Three Mile Island, Unit 1
Operating License No. DPR-50
NRC Docket No. 50-289

Subject: Response to Request for Additional Information Concerning Relief Request
PR-03 for the Fourth Ten-Year Interval Inservice Testing Program

**ADDITIONAL INFORMATION FOR PUMP RELIEF REQUEST PR-03
CONCERNING TURBINE-DRIVEN EMERGENCY FEEDWATER PUMP
COMPREHENSIVE PUMP TESTING REQUIREMENTS**

Figure 1
EFW Pump Flow vs Head with ASME 7% Acceptance

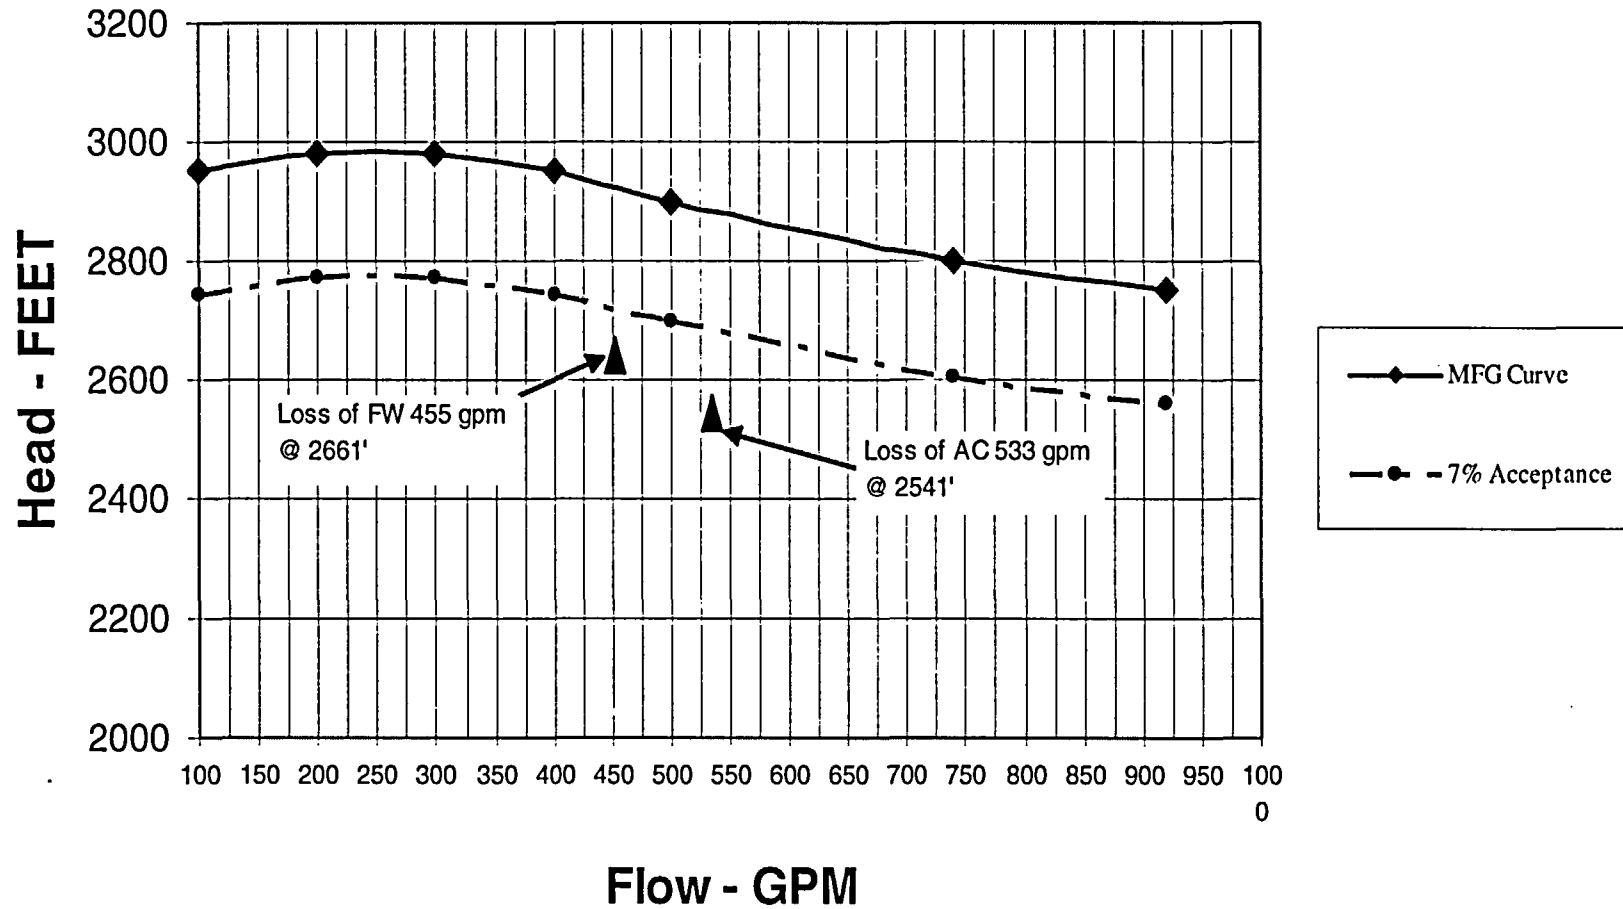
1. Figure 1 provides a plot of the pump head versus flow, based on the manufacturer's curve and the ASME 7% acceptance criteria. Also provided on this curve are the EF-P-1 required accident flow rates (total pump flow):

Loss of Feedwater Event (LOFW) – 272 gpm (455 gpm) at 2661 feet of developed head

Loss of AC Power Event (SBO) – 350 gpm (533 gpm) at 2541 feet of developed head

Figure 2
EFW Pump Flow vs Head with 9.7% Degradation

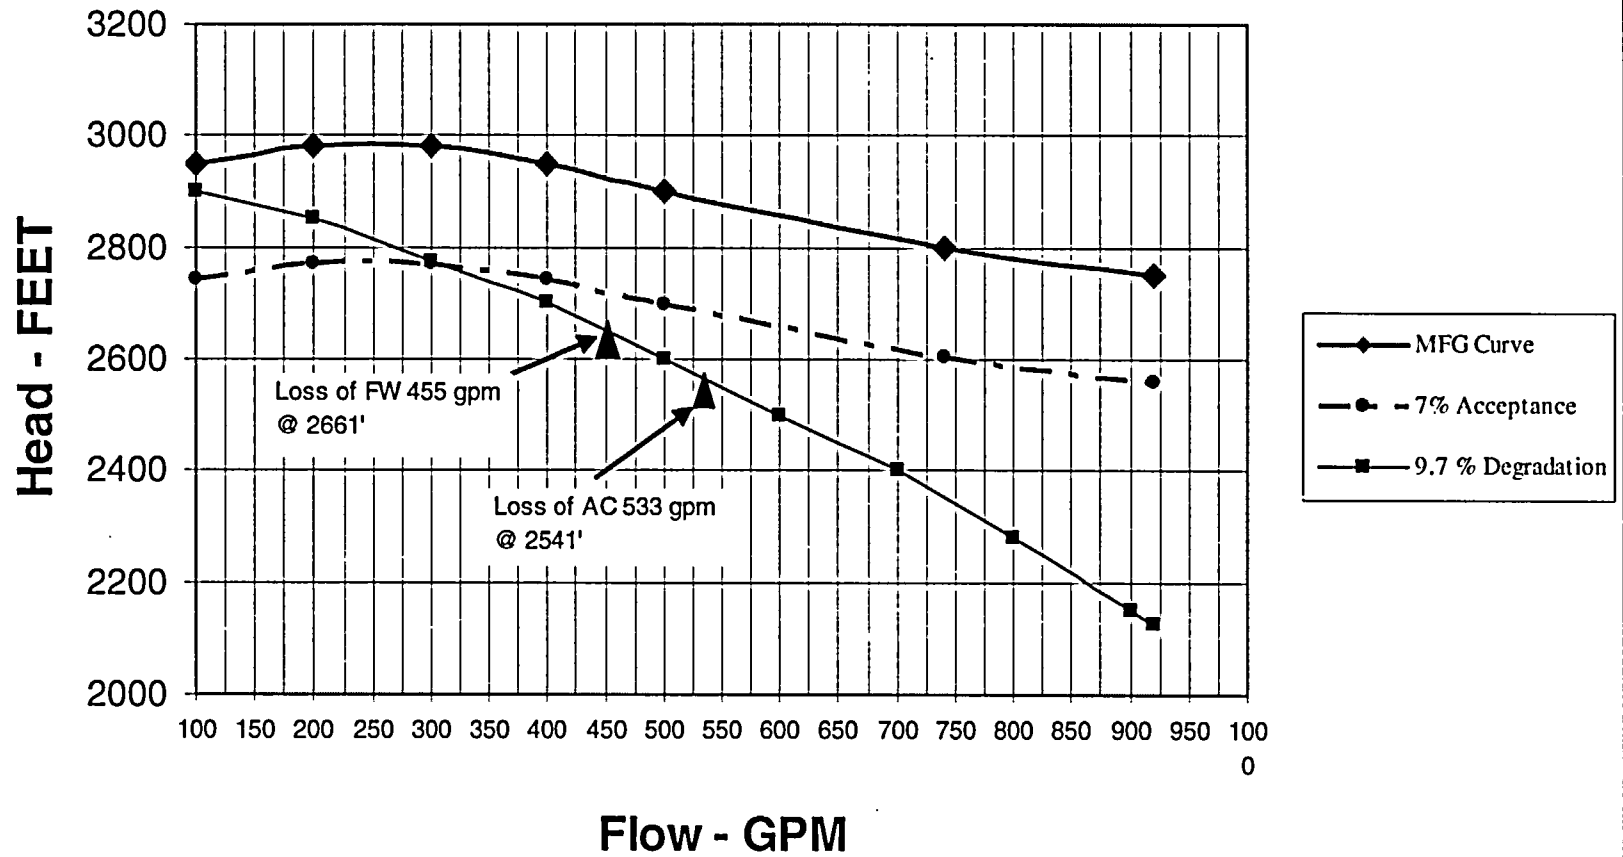
2. Figure 2 provides a 9.7 % degradation curve developed for the EF-P-1, which bounds the ASME 10% acceptance criteria for the current interval. The current inservice testing acceptance criteria were established in 1999 using the computer program RELAP5 to perform hydraulic transient analysis of the specific system configuration at TMI, Unit 1. This analysis used the original pump manufacturer's shop testing curve, as shown in Figure 1, as the basis for expected pump performance and benchmarked the pump performance testing during refueling outage 12R (1999). During this testing, a maximum flow of 675 GPM from EF-P-1 to OTSG "B" was recorded. This point was not the reference point, but was recorded to verify flowpath capability. (Current refueling interval testing of this pump includes testing at higher flowrates, but only for very short durations.) This calculation used for establishing the acceptance criteria also determined degradation curves for all of the emergency feedwater pumps. At the time of this analysis, a 9.7 % degradation curve was developed for EF-P-1. This degradation bounded the ASME 10% acceptance criteria, and also bounded the design accident requirements of EF-P-1. It should be noted that this curve is specific to EF-P-1.

Figure 3
EFW Pump Flow vs Head with Degradation Curves

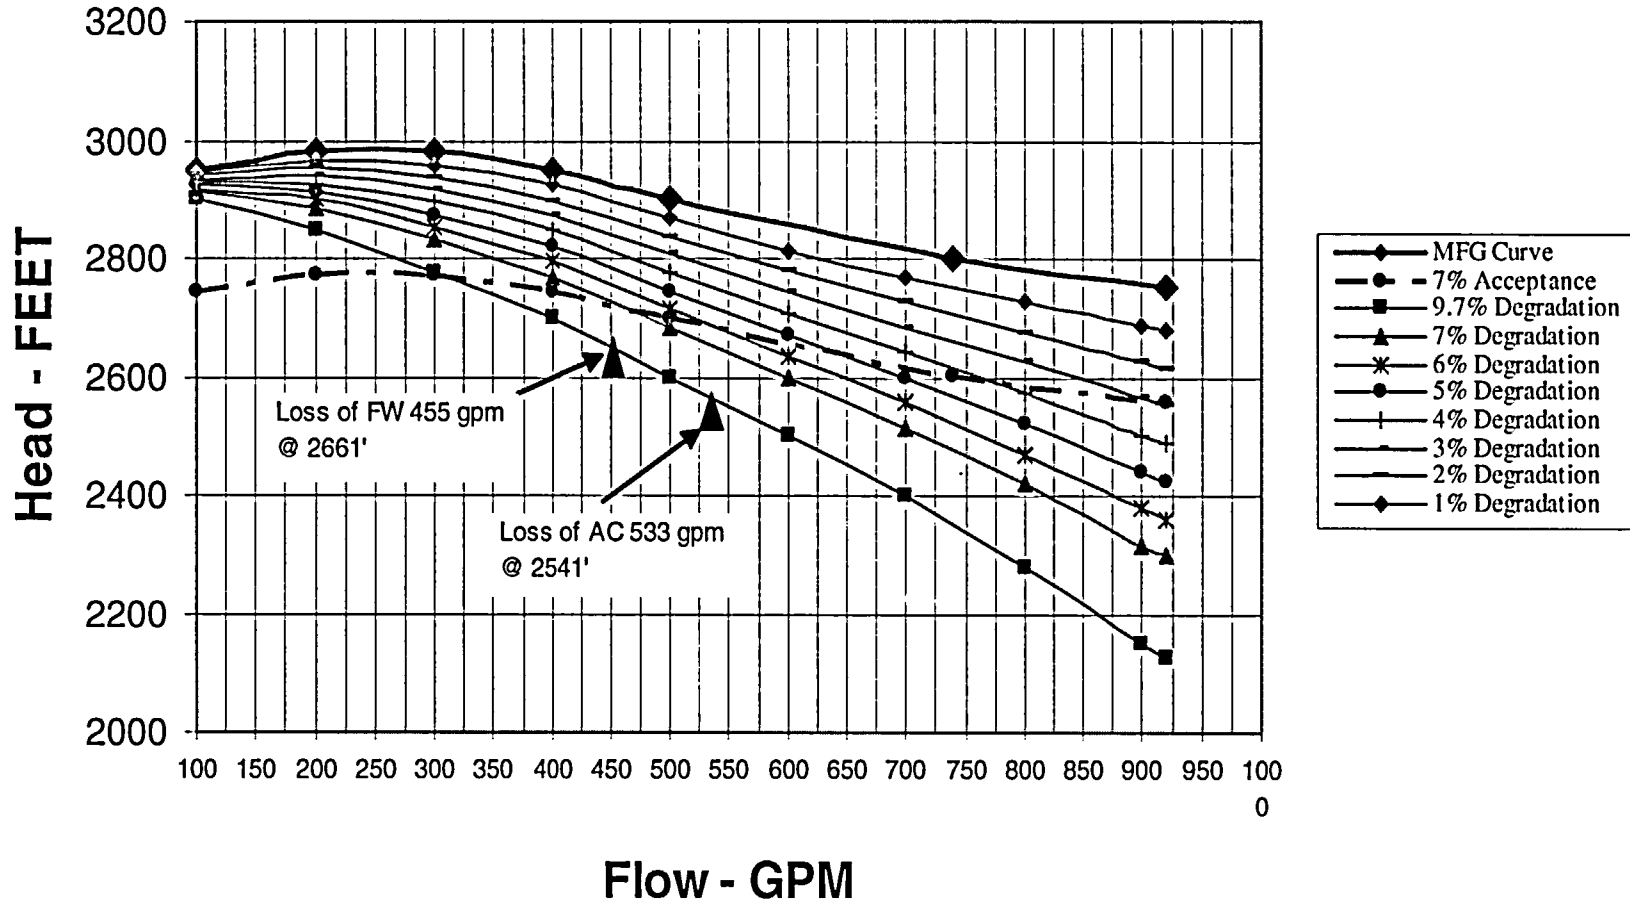
4. Recognizing delta P reference value is higher for higher flow while the change in delta P is smaller at a lower flow, the acceptance criteria needs to be adjusted for test results at the lower flow rate. For certain pumps, the 2% measured degradation could be 9% at the higher flow. Therefore to obtain approval for the lower flow, we must demonstrate that the adjusted acceptance criteria for lower flow can meet the code requirements of ISTB-3300(e)(1) for the comprehensive flow test. The information for staff review should include, but not be limited to, the methodology and technical data used for the adjustment of the acceptance criteria for the comprehensive flow test at the lower flow.

The following information provides a justification for a reduced acceptance criteria band while testing at a reduced flow. In summary, head versus flow degradation curves have been developed utilizing a polynomial fit for the acceptance criteria (Figure 3), which were based on the RELAP5 model for hydraulic transient analysis of the TMI, Unit 1 EFW piping configuration and capabilities. This model contained a degradation curve for an estimated 9.7% degradation of pumping capability for EF-P-1 based on a RELAP5 calculation. This model was developed to support Technical Specification Change Request 279, Core Protection Safety Limit with an Average of 20% Steam Generator Tubes Plugged, dated December 3, 1998. This Technical Specification Change Request was approved in an NRC Safety Evaluation dated August 19, 1999. In that Safety Evaluation, "the staff reviewed the proposed methods for evaluating the EFWS performance and establishing surveillance test acceptance criteria using the RELAP5 model and finds them to be acceptable." Using this degradation curve and the original pump manufacturer's head curve, additional curves at various degradation levels were developed. These head versus flow curves can be compared against the original manufacturer's head versus flow curve and the current ASME 7% acceptance criteria. These curves will allow extrapolation from the lower flow of 500 gpm, to expected results at the higher flow of 740 gpm.

3. Using a polynomial curve fit of the RELAP modeled 9.7% degradation curve at 3800 RPM, degradation curves from 1% to 7% were generated as shown in Figure 3. This graph displays these curves along with the manufacturers curve and the ASME 7% acceptance curve. The following equations were generated for each of the degradation curves presented:

Figure 4
Example EFW Pump Flow vs Head using Degradation Curves

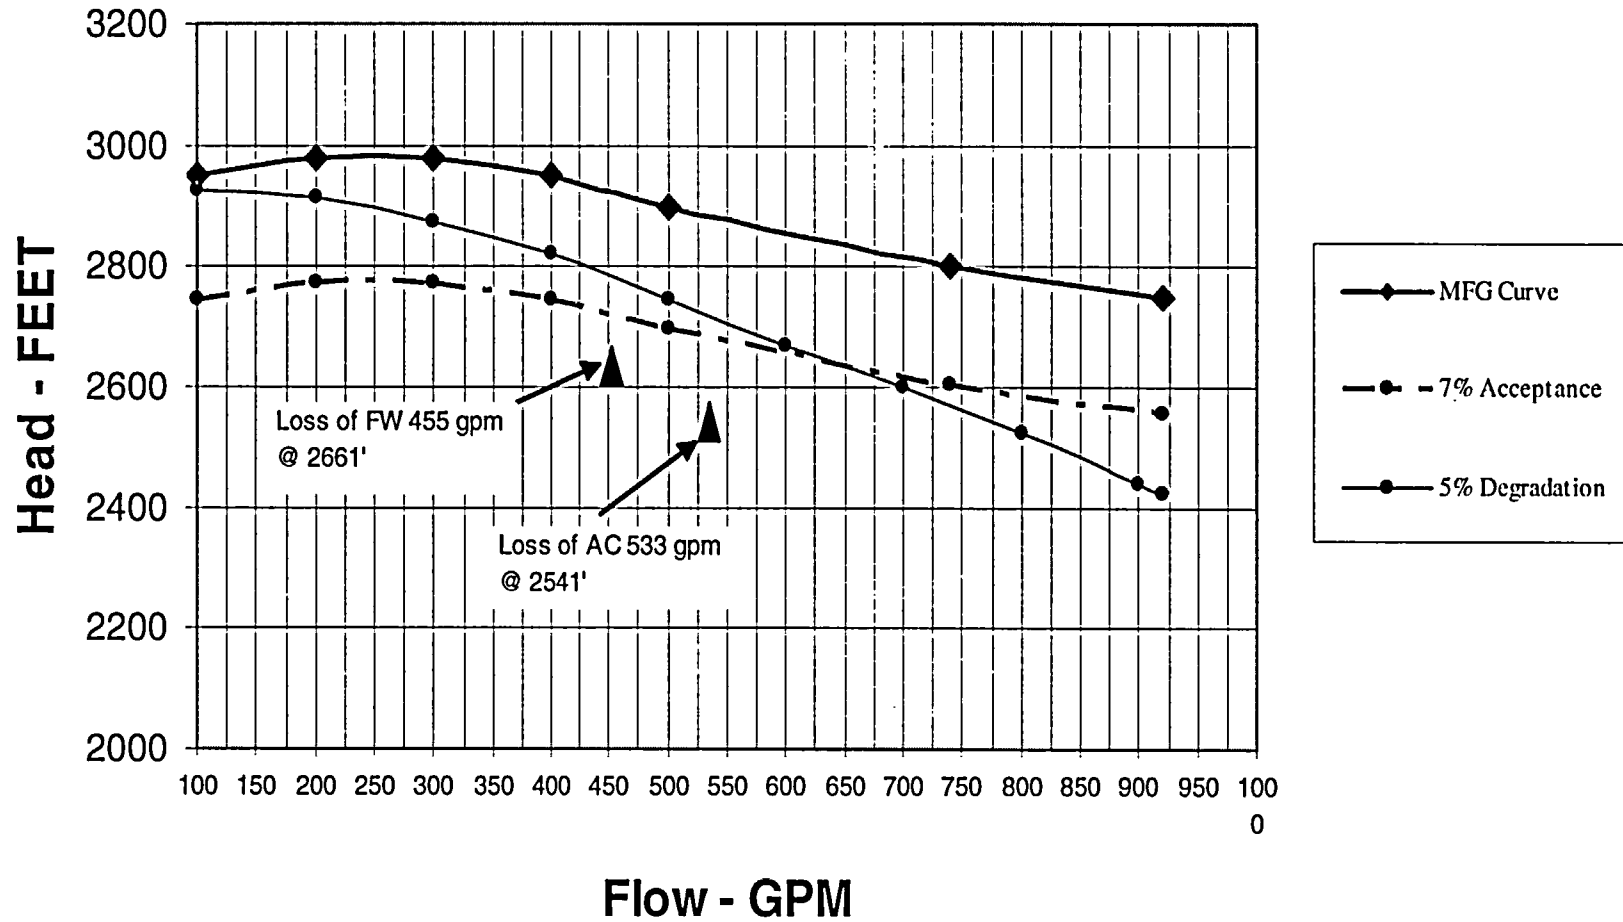
5. The following is an example (See Figure 4):
 - a. During the EF-P-1 test at 500 gpm, the differential pressure is calculated to be 2745 ft. At this test point, the pump meets the criteria in i) and ii) above. However, at the reference point of 500 gpm, the differential pressure of 2745 ft. corresponds to 5% degradation. When the 5% degradation curve is applied and extrapolated to 740 gpm (ASME required test flow point), the acceptance criteria of 7 % is not met. The pump would then be declared inoperable per TMI procedures. Additional testing would be performed as necessary to evaluate pump performance and to identify the most probable cause of the deviation. The condition will then be corrected or an analysis would be performed to determine the need to establish new reference values.
